Joseph M. Farley Nuclear Plant Units 1 and 2
Bechtel Jobs 7597-011/021
Electric Hydrogen Recombiner Splices -
Justification for Continued Operation
(PCR NO. 87-0-4441)
Bechtel Files A-78, E-91
AP-13525

SUBJECT: Evaluation of splices used on Hydrogen Recombiner heater leads to field cables.

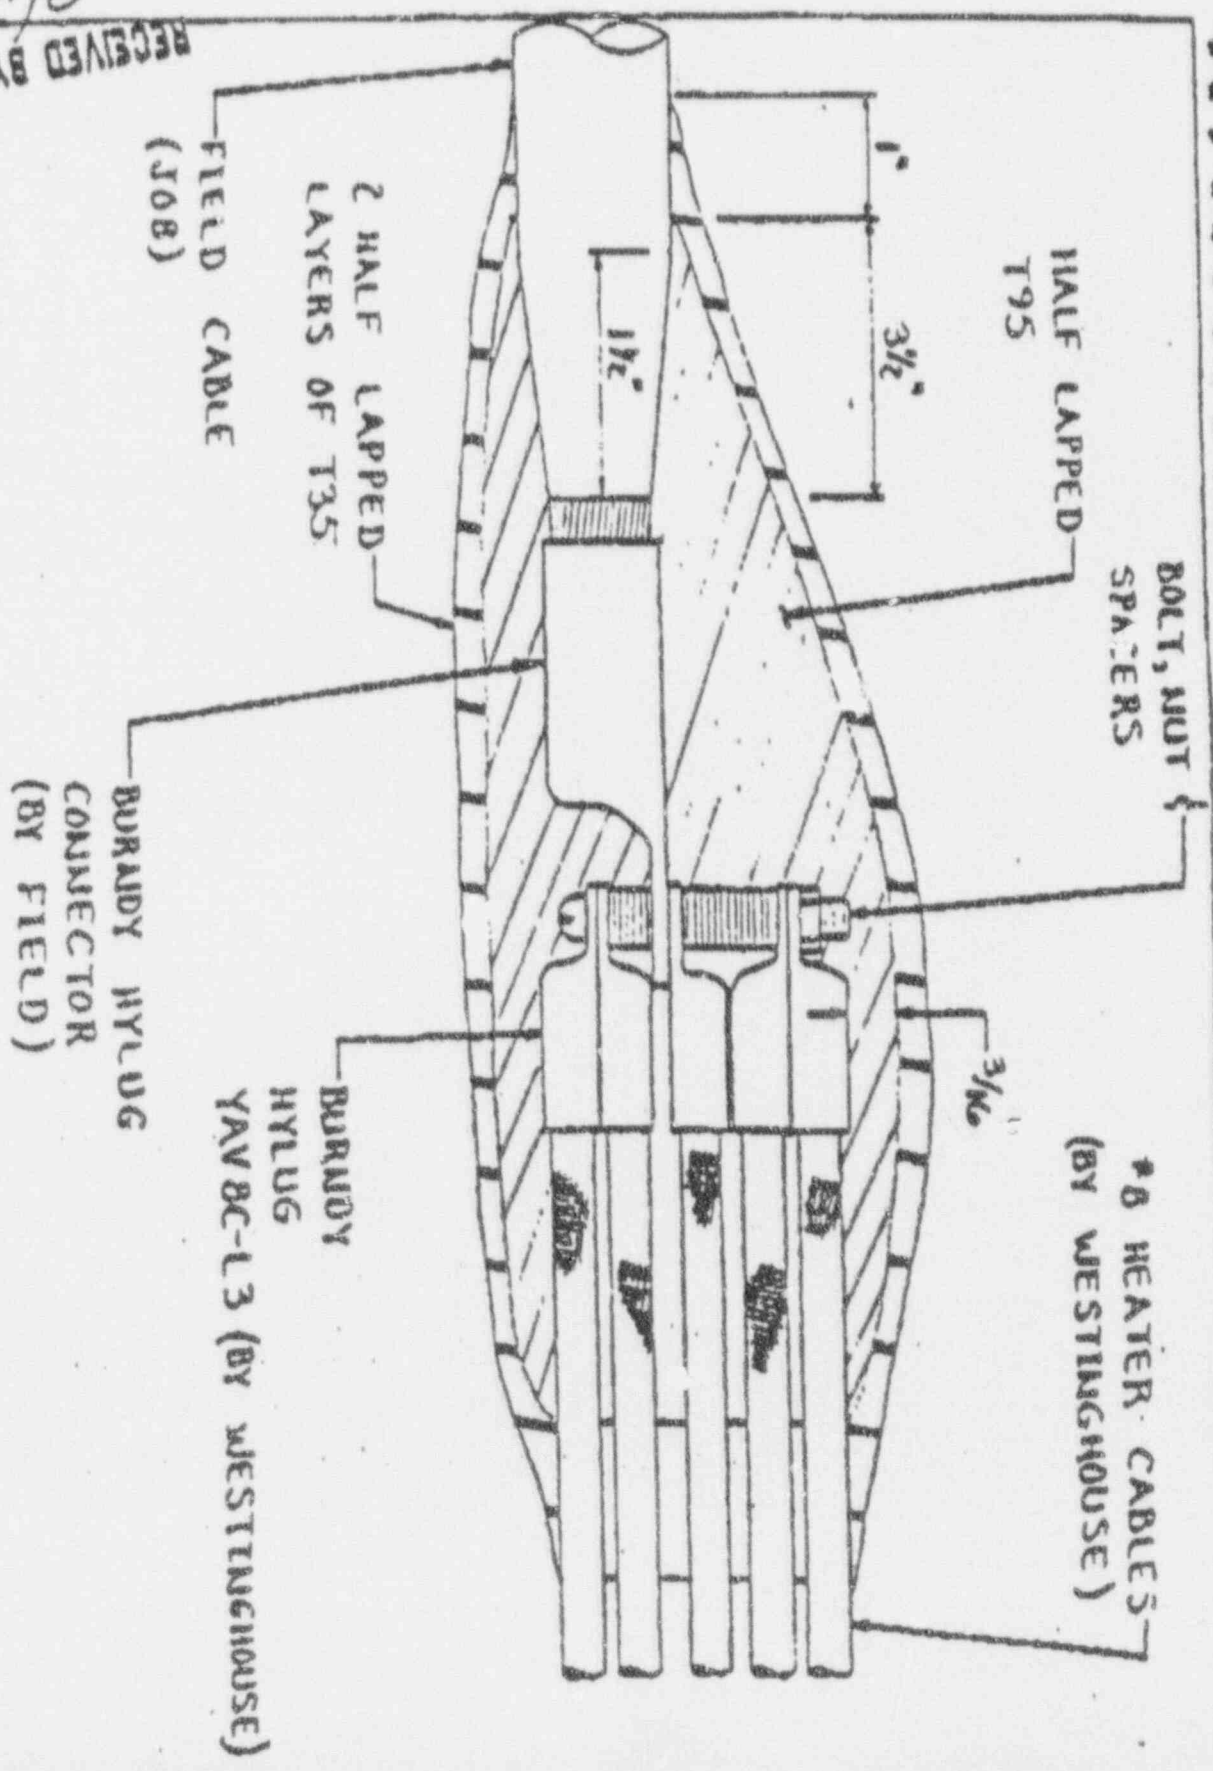
This evaluation assumes that the field cable to heater bank lead terminations have been made using a bolted lug connection which is insulated by Okonite T95/T35 tape materials. It is assumed that the existing thickness and splice overlaps are as shown on the sketch included as Appendix A.

The thickness of the T95 insulating tape installed per the attached Appendix A detail provides adequate phase to phase and phase to ground electrical insulating properties for 600 Volts service.

The splice configuration shown in Appendix A coupled with the qualification tests performed by Okonite provides reasonable assurance that this splice detail will perform its intended function in the relevant environments. Therefore, continued operation of Farley Nuclear Plant Units 1 and 2 is justified.
